Public Transport Users Association

Submission on the Ballarat Station Upgrade

Level Crossing Removal Authority

5th July 2024

Diagram showing upgrades proposed by the project and improvements recommended by the PTUA

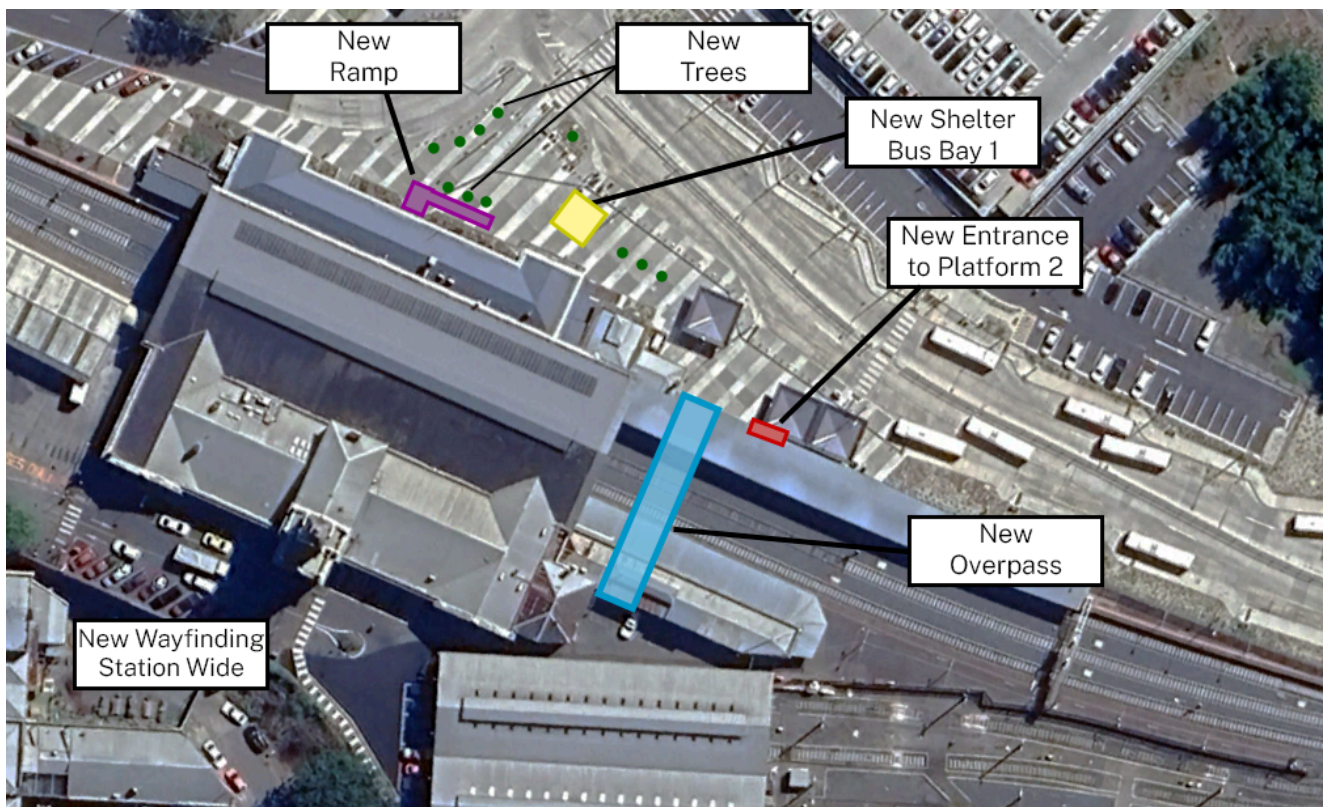
- The creation on an additional entrance on the eastern side of platform 2,
- The new overpass to protect users from the weather,
- The construction of an additional shelter at bus bay 1,
- More passenger information screens,
- A station-wide wayfinding review,
- Planting of trees in the northern forecourt

However we believe that the current proposal falls short when it comes to accessing the overpass from the northern forecourt, which is the primary access point for those getting to the station by local bus or car. The proposal involves replacing the existing bluestone step with a new ramp. While that is a welcome improvement, it does not involve the “entry room” between the forecourt and the platform. That room has some attractive and historic architectural elements, but is extremely impractical for a modern transport hub.

Due to the narrow doorway, it is not uncommon to see the room full with passengers as they try to exit during peak times, creating difficulties for those trying to enter at the same time. The entrance was never intended to be the main access point for the station, but has become so due to the newly built bus interchange and multi deck carpark. To take pressure off that space, the PTUA recommends cutting out a section of fence further east, thereby creating a second entrance point to platform 2 that avoids the heritage structure altogether. This second entrance would also be located near the new overpass, allowing direct access across to platform 1.

In addition, we advocate that an additional shelter be constructed at the bus interchange for passengers waiting for buses at bus bay 1. The nearest shelter is too far away to allow passengers to get to their bus before it departs.

In addition to that, we feel that additional summary information displays should be installed at all entrances to the station, including the entrances to both platforms from Lydiard St, as well as our proposed additional entrance to platform 2 from the bus bay.
